Subject: Request for Time Division Multiple Access (TDMA) Waiver for AN/PSC-5D Terminal

SUBJECT: AN/PSC-5D (RT-1672D(c)/U) INTEGRATED WAVEFORM CONDITIONAL TEST  
CERTIFICATION (WAIVER) RECOMMENDATION

SUBJECT: Request for IW Certification Waiver for the AN/PSC-5D UHF SATCOM terminal

**Figure 1. Though in some cases the AN/PSC-5D exceeds the relative ACE limits (yellow), it always keeps below the more critical absolute ACE limits (red).**

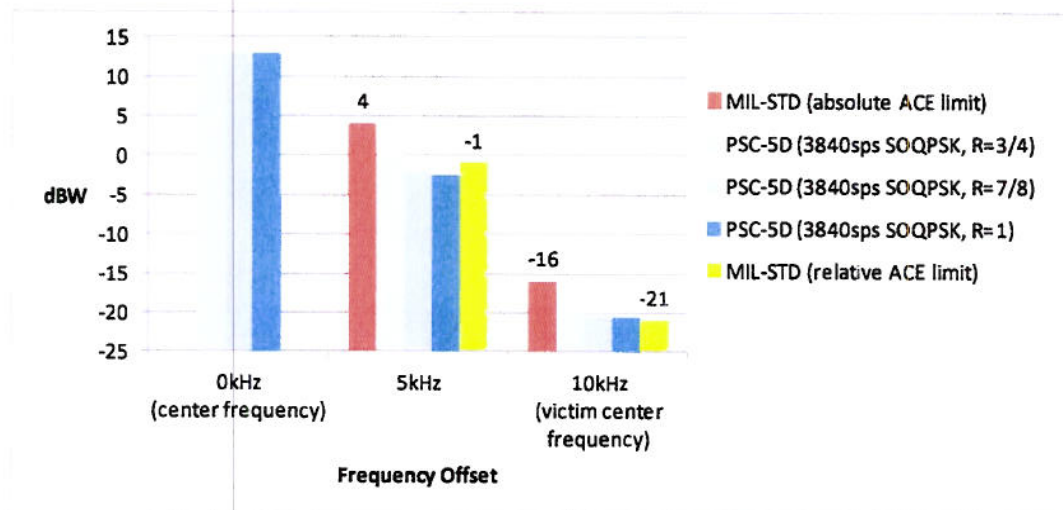
a. The MIL-STD requirements for ACE and the associated method JITC uses to test and report compliance are rather complicated. (Note: This complexity results mostly because the requirements are levied on EIRP, not simply power, and this means JITC must account for the gain of the antenna assembly, which makes compliance a function of the antenna being used.) But in short, there is both an absolute and a relative ACE requirement. The first is the most important in terms of performance impact on neighboring channels. It requires that transmitters keep their absolute amount of ACE EIRP below limits that prevent users on adjacent channels from being impacted in a adverse way. Focusing then only on the area of failures, i.e., narrowband PSK ACE at 5KHz and 10kHz offsets, Table I of MIL-STD-188-181C reflects the determination that, for the transponder sizes and modulations in question, these limits are 4dBW at 5kHz away from center, and -16dBW 10kHz away from center. No matter how much power a terminal has or how big its antenna, these are the physical limits that cannot be exceeded without beginning to affect other users/systems. Note that per the JITC assessment, the AN/PSC-5D does not fail the absolute part of this requirement. JITC only notes correctly that operational training and discipline is required to ensure that users know what power settings and antenna gains can be used without exceeding system ACE limits. But Table I of MIL-STD-188-181C also contains a second limit on the amount of transmitted EIRP ACE relative to the peak carrier power. This requirement ensures that vendors are not free to totally neglect ACE simply because the terminal is not being used at higher power

settings. The relative requirement stipulates that even at lower powers, i.e., any value less than +18dBW (or 63 Watts), the terminal must still keep its ACE EIRP to -14dB relative to the carrier power (dBc) at a 5kHz offset, and -34dBc at a 10kHz offset. It is this relative requirement that JITC failed for certain modulations as shown in Table 1.

b. JITC is doing its due diligence and correctly testing and reporting the requirements as written. But from the standpoint of operational impact, the terminal is in fact passing the requirement that matters most to the user in the adjacent channel, which is obviously the absolute requirement. It is of no importance to an operator whether the amount of interference from a neighbor is small relative to its maximum transmit power. What matters for performance is the absolute amount of energy entering the victim band. To see this, consider that the relative nature of the requirement means that even if the terminal is set to its lowest possible power output of 0.2W, it would still fail the requirement, although at power levels this low certainly no adverse impact to anyone would be possible. But the key point here is that even though JITC has determined a failure to meet the relative ACE requirement of  $(P_{max} - 14\text{dB})$  at 5KHz and  $(P_{max} - 34\text{dB})$  at 10KHz, respectively, because the maximum output power of the AN/PSC-5D is only +13dB, far less than the +18dB at which point the absolute requirements apply, this means that the terminal still has significant margin before it begins to exceed the requirements set on absolute ACE. This is illustrated in Figure 1, which shows the JITC data with the important context of comparing the relative numbers to the absolute ACE requirements. This makes it clear that even though three modulations exceed the relative limit at the 10kHz offset and one modulation exceeds the relative limit at the 5kHz offset, in every case, the ACE values are as much as 3-5 dB below the absolute limits at which point users on adjacent channels will begin to be impacted. This margin is important because the peak output power of the AN/PSC-5D is 3dB less than the minimum required EIRP of 16dB, and therefore an antenna of at least 3dB is needed to meet this requirement (see para. 10a of the JITC assessment letter). So, for example, the worst-case nonconforming modulation is 1.78dB above the allowed ACE limit at 10kHz. But setting the radio to its peak power of +13dBW, adding a 3dB antenna for +16dB EIRP should result in a 10kHz ACE of  $(+16 - 34 = -18\text{dBW})$ . Yet, the additional 1.78 dB only takes the ACE to -16.22, which is still 0.22dB below the absolute MIL-STD limit of -16 dB. Note also that even these "absolute" limits were designed with built-in margin.

c. Consider further that IW terminals do not use these 3840 sps SOQPSK modulation options when inter-operating with other IW terminals. Rather, this is an older modulation that IW terminals use only when operating in "backwards-compatible" comms with legacy (DAMA) terminals that do not have the IW upgrade. Even then, these modulations are used only when the DAMA terminals are using a 5-kHz (narrowband) channel (all wideband, i.e., 25-kHz transmissions comply with ACE requirements). Also, the nonconforming modulations arise only in the case of multiple-access, i.e., the terminal is assigned to a timeslot and not an entire channel. Even in this case however, other PSK modulation options exist that are ACE-compliant and which could be used for the provisioning of networks that host both DAMA and IW terminals.

- a. The one item identified as having a "major," but not "critical" impact involves adjacent channel emissions (ACE) on an older modulation scheme. IW terminals use this modulation scheme when operating in "backwards-compatible" communications with legacy DAMA terminals. USASMD/ARSTRAT does not foresee a requirement to use this mode during IW testing.

b. This terminal shall not use the 3840 symbols per second (sps) PSK modulation option when interoperating with other IW terminals or for "backwards-compatible" communications with legacy DAMA terminals.

Figure 2

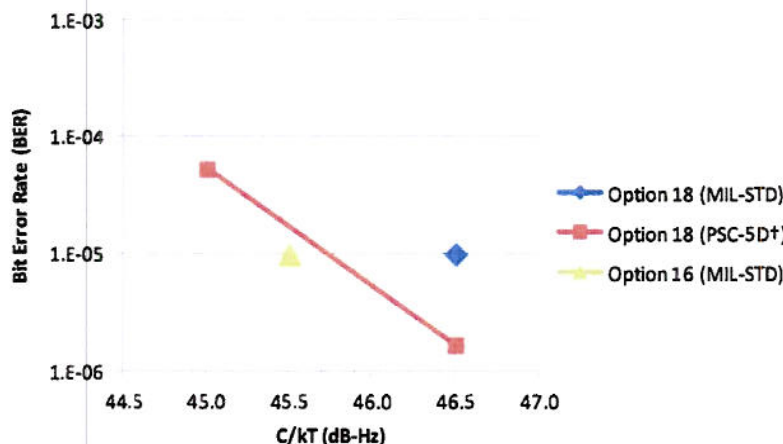
5. No Support for Option 16 Failures. In paragraphs 10i/k, JITC determined a failure to meet requirements 44 and 116 of MIL-STD-188-181C. Both of these trace to the fact that the AN/PSC-5D does not support mandatory modulation option 16, i.e., 6000bps CPM for single access operation.

b. DISA concurs with the JITC assessment that this causes a mere “minor” operational impact, but offers the following justification. For one thing, these impacts are minimal because this failure only affects single access (SA) operation, which, using Phase I experience as a guide, is rarely if ever used since multiple access (MA) operation is much more efficient and commonplace. Even then this limitation is only encountered when operating on 5kHz channels and when the desired data rate is 6000 bps. Even granting however that this exact scenario should occur, the only impact would be that without Option 16, planners would have to assign either Option 13, which provides superior BER performance, albeit at a slightly reduced data rate (4800bps), or Option 18, which provides 7200 bps, but per MIL-STD-188-181C needs 1.0 dB better link quality in order to maintain BER less than the  $1E-5$  threshold for data traffic. Note however that according to experimental data collected for DISA on a satellite simulator that is an exact replica of the filters of the UFO satellites, as shown in Figure 2, the AN/PSC-5D implementation of Option 18 out-performs the MIL-STD requirement for  $BER=1E-5$  by about 0.8dB. Therefore, any user who would be assigned Option 16 for 6kbps data transfer can use Option 18 and receive a higher data rate with negligible performance impact (0.2 dB) to data transfers. From the figure it is clear that this translates to receiving about  $1.5E-5$  BER instead of the desired  $1.0E-5$ . This is certainly on par with the BER deviations that have been granted waivers for this and other terminals, and demonstrates that Option 18 is a very adequate substitute for the missing Option 16.
